PLANNING AMENDMENTS

TWICKENHAM STADIUM EAST STAND EXTENSION

GA SECTION A

SECTION A SECTION GA 1:200

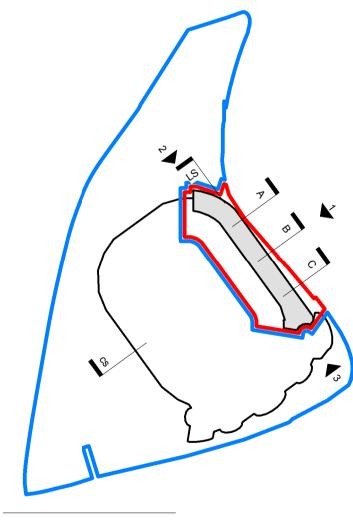
GENERAL AMENDMENTS TO THE SOUTH END. INCREASED SHINGLES CLADDING AREA AND CURTAIN WALL REDUCED ACCORDINGLY. REDUCED MASSING AND REVISED INTERFACE WITH

- THE SOUTH STAND.
- PPC LOUVRES LOCATED TO THE BOWL SIDE HAVE
- BEEN OMITTED.
- CURTAIN WALL SETTING OUT REVISED GENERALLY.
 SILICONE JOINTS TO TRANSOMS AND MULLION
 REPLACED WITH CAPPED SYSTEM. LEVEL 04 PPC
 LOUVRES SETTING OUT & HEIGHT REVISED. MONORAIL
- FOR ABSEILING REMOVED.

GENERAL AMENDMENTS TO THE CENTRAL ELEVATION
 CANOPY AT LEVEL 5A REVISED GENERALLY AND
 STANDING SEAM REPLACED WITH SINGLE PLY MEMBRANE. SUPPORT COLUMNS TO ROOF CANOPY REVISED. SQUARE FASCIA TO ROOF EDGE.
- LEVEL 5A GLAZED SCREEN EXTENDED IN HEIGHT AND PPC LOUVRES INCLUDED AT LOW LEVEL.
 INCREASED SHINGLES CLADDING AREA AND CURTAIN

WALL AREA REDUCED ACCORDINGLY. FOUR VERTICAL

- FINS REMOVED.

PORCELAIN PANELS WITH SLOTTED HOLES FOR VENTILATION REPLACED WITH PPC LOUVRES.

EXPRESSED HORIZONTAL PATTERN TO PORCELAIN PANELS OMITTED.
- GENERAL AMENDMENTS TO THE NORTH END
 PORCELAIN CLADDING REPLACED WITH PPC ALUMINIUM
- CLADDING. GREEN WALL TO THE NORTH END EXTENDED AND PPC LOUVRES REMOVED.
- INCREASED SHINGLES CLADDING AREA AND CURTAIN WALL REDUCED ACCORDINGLY.
 FENCELINE, GATE AND PERIMETER COLUMNS SETTING
- OUT REVISED.
 CANOPY TO TURNSTILES REVISED.
 PORCELAIN PATTERN CHANGED FROM HORIZONTAL TO
- VERTICAL. PORCELAIN PANELS TO THE SOFFIT OF THE ARCH REPLACED WITH PPC ALLUMINIUM PANELS. PORCELAIN
- PANELS SETTING OUT REVISED. ROOF TO LEVEL 5A (NORTH END) EXTENDED.
- GLAZED SPANDREL PANELS REPLACED WITH METAL SPANDREL PANEL. PORCELAIN PANELS REPLACED
- WITH PPC ALUMINIUM CLADDING.
 PPC LOUVRES INCLUDED FOR MECHANICAL VENTILATION.
